CBD & South East Light Rail Project  
EIS Response for UNSW

## CBD & South-East Light Rail Project Project SSI 6042

## UNSW Submission to the CBD & South-East Light Rail Project incorporating the Preferred Infrastructure Report

Submitted to Planning & Infrastructure  
On Behalf of University of NSW

**Figure 1** – Comparison of Level of Service from relevant guidelines  
Source: Traffix Group

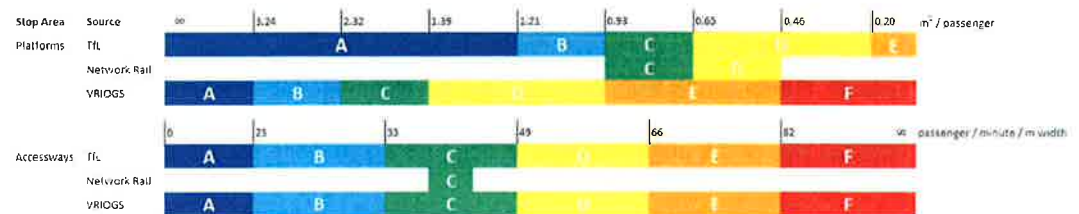
Figure 1 below provides a graphical comparison of levels of services under each guideline for platforms and accessways. This Figure is also found in the document at **Appendix F**. Generally, a LoS 'C' is considered acceptable under these various guidelines.

Additionally, the VRIOGS is deemed appropriate as it relates specifically to surface-based rail infrastructure in an Australian context, and importantly an environment that is freely accessed by users / pedestrians without barrier controls. That is, passengers are able to access platforms from a variety of directions within a largely uncontrolled or unmanaged environment, unlike say an underground railway station without open distractions, other vehicles, and other externalities at play that influence the light rail stop environment.

Accordingly, the VRIOGS has informed the UNSW Concept Designs for both stops, which are recommended as the refined designs to accommodate the likely demand at UNSW and provide the standard of safety, security, and efficiency sought by UNSW and TfNSW. Accordingly, the UNSW alternative concept design platforms, access ramps and pedestrians crossings have all been designed to meet a LoS 'C' under this Standard.

Figure 2 – Current and future locations of environments sensitive to noise, vibration, EMI and RFI  
Source: UNSW

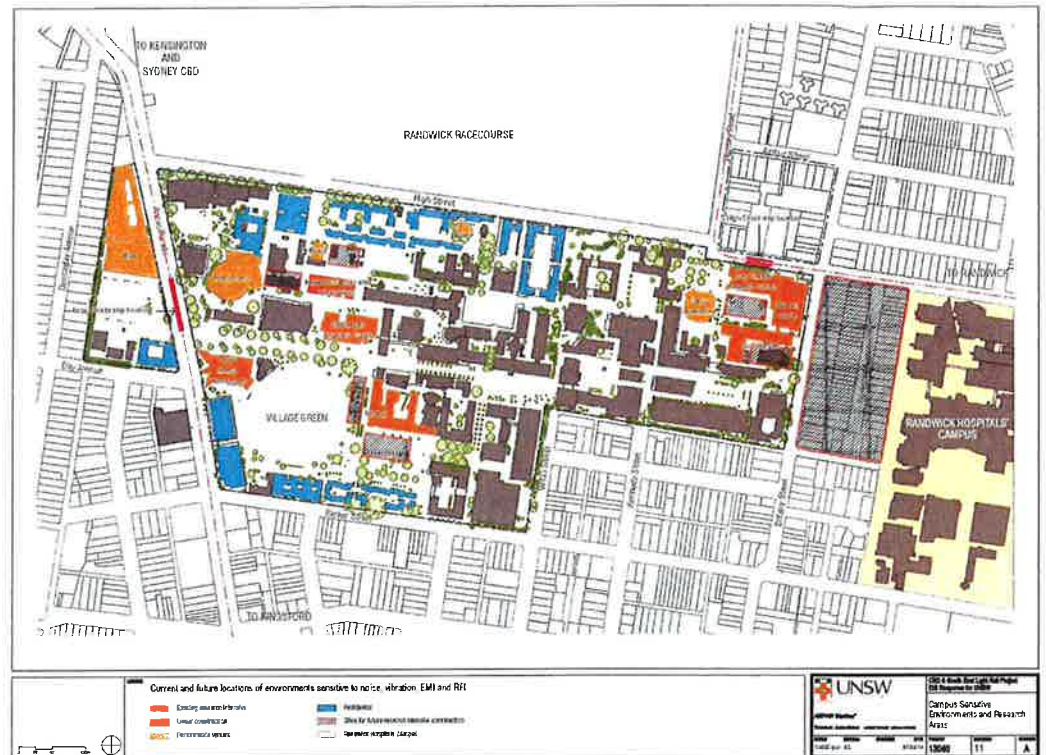
The above locations are not fixed and are also subject to change. Accordingly, information can be provided as it becomes available as well as throughout the proposed UNSW sign-off processes under various suggested conditions of approval.

To ensure normal business is able to continue for UNSW and it is able to provide teaching and research consistent with its obligations to its students and its charter, particularly in relation to exam conditions, careful consideration needs to be made to prevent construction impacts during these periods and to preserve consistent amenity.

For UNSW the relevant research facilities are recently constructed or fitted out, are under construction or are planned for construction. They include but are not limited to the purpose built Lowy Cancer Research Centre, the Wallace Wurth Building, the Tyree Energy Technologies Building, the BioSciences Renewal Project stages 1 and 2, the Newton Building, the Old main Building, the Material Sciences and Engineering Building Stages 1 and 2, TETB and the Mark Wainwright Analytical Centre. Some are located opposite, and within 25m of, the proposed light rail stop on High Street or the proposed light rail stop on Anzac Parade..

As is in evidence from the University of Minnesota case there is a clear potential for vibration and EMI/RFI impacts that significantly impede the ability for particular research to be progressed at the University, putting at jeopardy the entire research mission of various research centres. This has not been adequately assessed by TfNSW.

In particular, it is unknown what level of noise, vibration, EMI and RFI the CSELR project will have on the identified sensitive environments, what source and other mitigation measures may ameliorate the impacts to these sensitive environments to prevent jeopardising the University's various research missions, or the levels of noise, vibration, EMI and RFI that currently exist.

With regard to the possible mitigation measures (identified above) it is noted that there is limited potential for retro-fitting vibration reduction and EMI/RFI cancellation devices, which are essentially experimental at this time. In the absence of specific impact assessment to determine whether the impacts are acceptable, a prudent and precautionary approach would be to minimise the impacts as much as possible in the first instance. This could be achieved through relocation of the light rail tracks as far to the north as possible for the High Street stop – meaning an alignment along the northern edge of High Street, rather than the currently proposed alignment in the centre of High Street. Whilst this is only a small distance it is virtual doubling of the distance from the Lowy Cancer Research Centre, which is a key research environment, it is highlighted that the levels of EMI/RFI at a receptor have been advised to be directly proportional to the inverse square of the distance from the source. Given this, a small increase in the distance between the source and the receptor can result in significant reduction in EMI/RFI at the receptor.

Whilst there is no guarantee (in the absence of a detailed impact assessment) that relocating the light rail tracks to the northern edge of High Street would reduce noise, vibration, EMI and RFI below unacceptable levels, it would result in impacts as low as reasonably possible.

EMI and RFI is caused by the operation of the light rail system, including the acceleration and deceleration of and the source of power to the LRV. The alternative concept design of the High Street stop and pedestrian plaza will lower the speed and lower the acceleration and deceleration of the vehicle and therefore lower the amount of EMI produced. This lowers the potential amount of EMI and RFI requiring mitigation. Consideration needs to be given to alternate sources of power supply to the LRV as power supply through catenary wires is a known source of EMI and RFI.

Further, irrespective of the location of the CSELR tracks on High Street, it will be imperative to have a suitably robust and comprehensive condition of approval which protects UNSW and in particular protects the research mission of the University. Existing EMI/RFI levels have not been established by TfNSW and the time frame for this work may be extensive. There is a possibility that source mitigation measures will not be sufficient. Suggested conditions in this respect form part of **Appendix B**.
